Conference Call Agenda Underfrequency Load Shedding (Project 2007-01)

1. **Title:** Automatic Underfrequency Load Shedding
2. **Number:** PRC-006-01
3. **Purpose:** To establish design and documentation requirements for automatic underfrequency load shedding (UFLS) programs to arrest declining frequency and assist recovery of frequency following underfrequency events.
4. **Applicability:**
 - 4.1. Planning Coordinators
 - 4.2. Distribution Providers that do not have an agreement with Transmission Owners to provide UFLS
 - 4.3. Transmission Owners that have an agreement with Distribution Providers to provide UFLS
5. **(Proposed) Effective Date:** TBD

Overfrequency Curves for Requirements R5.2 and R6.2

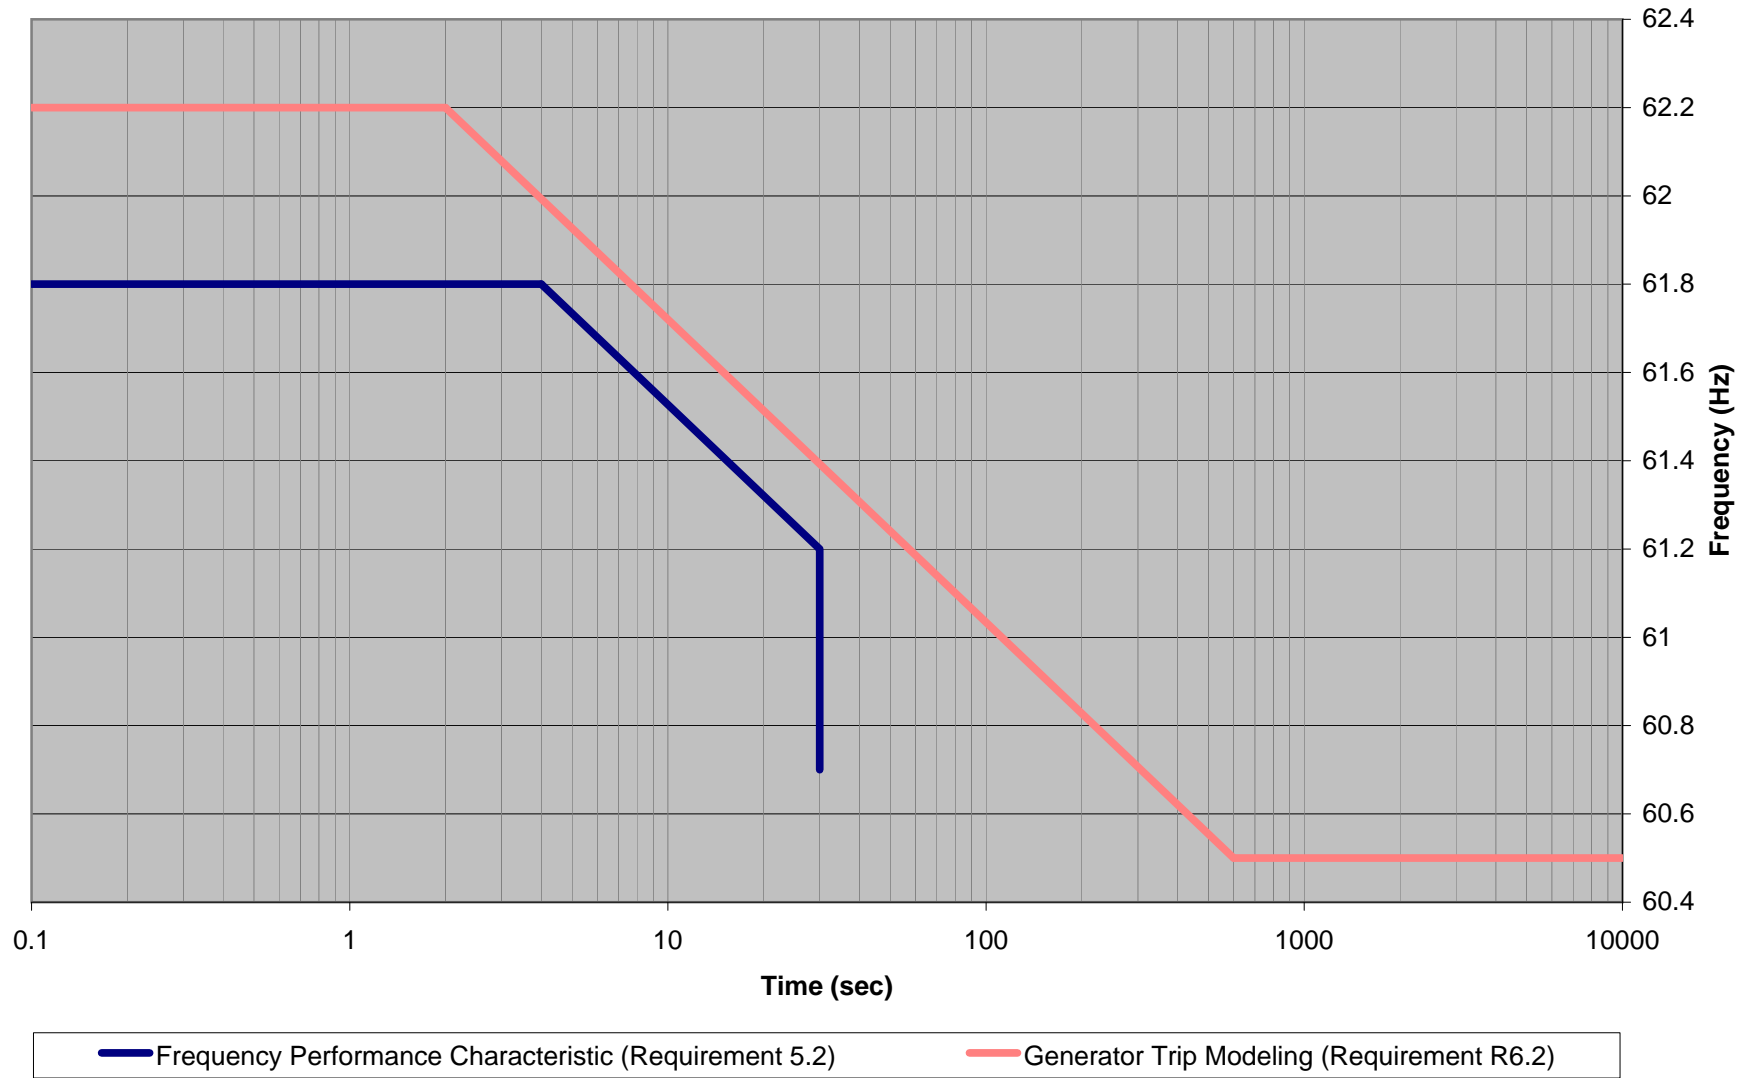
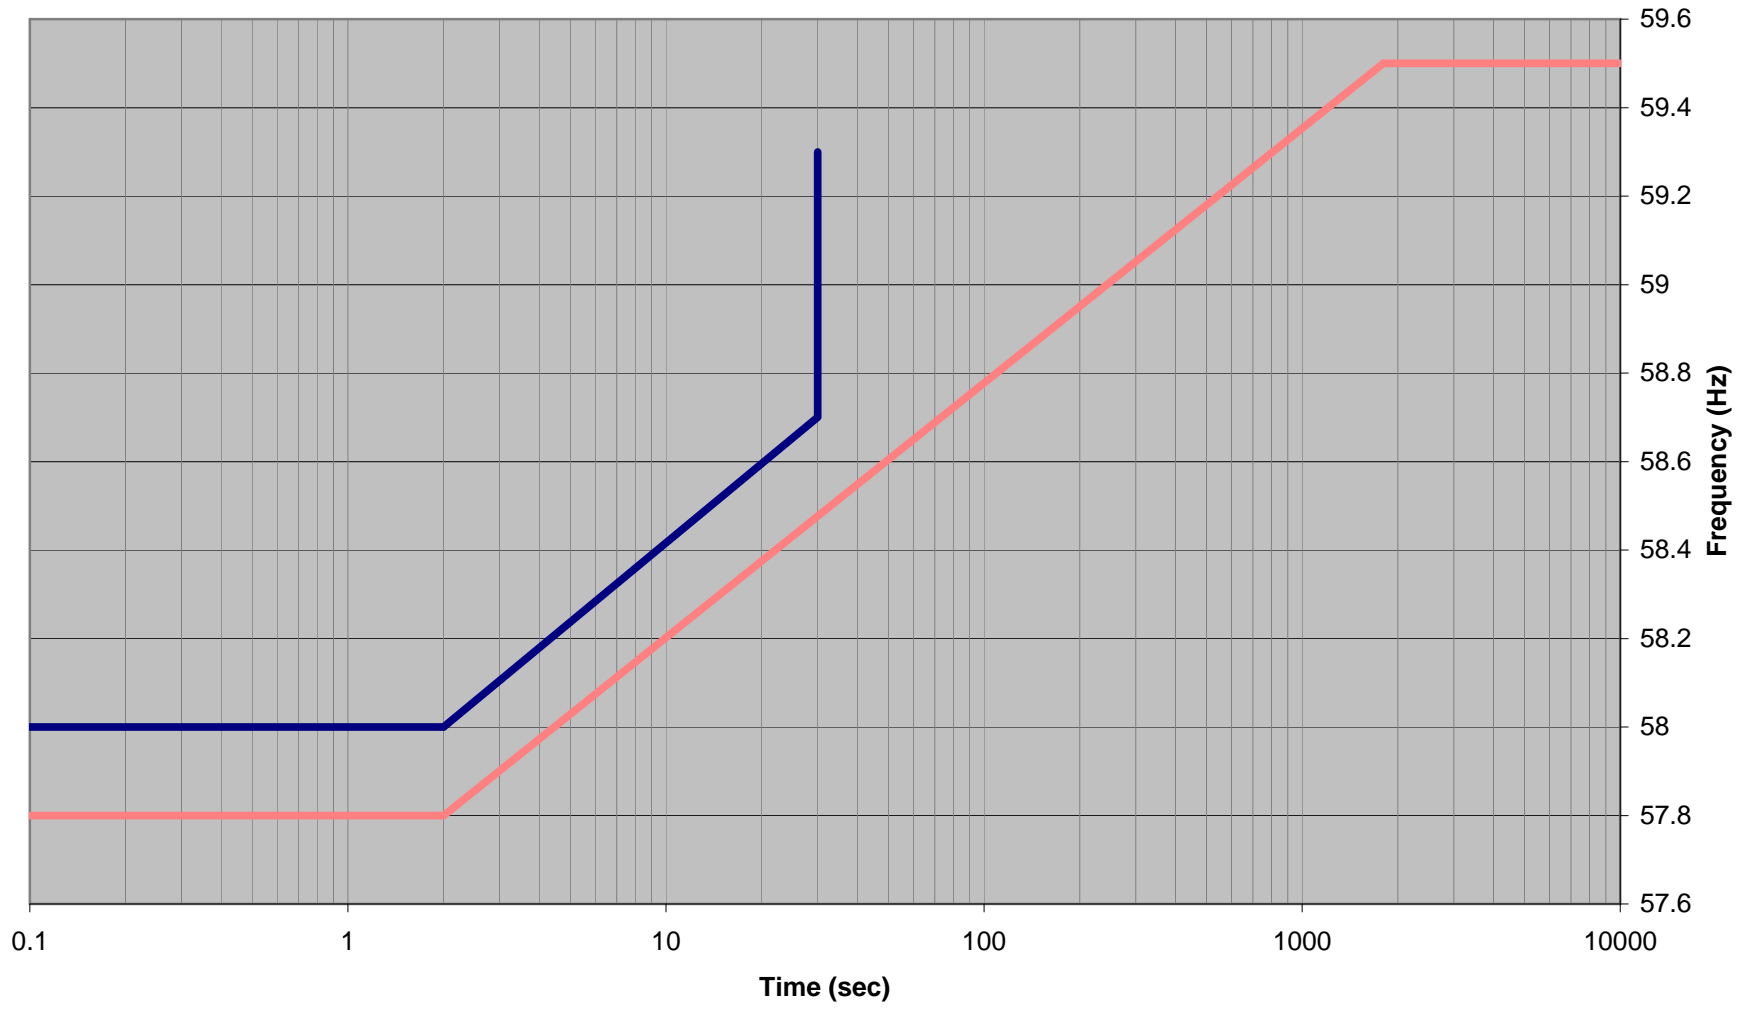
- Comment [sm2]:** if replaced by a curve (4.1) - Hydro would still require a Variance but WECC would be ok with what is proposed - MRO? uf curve would replace 4.1, 4.2 ofc would replace 4.3

- Comment [pjt5]:** We will include the proposed PRC-024 curve as the criterion for determining which generator protections must be modeled.
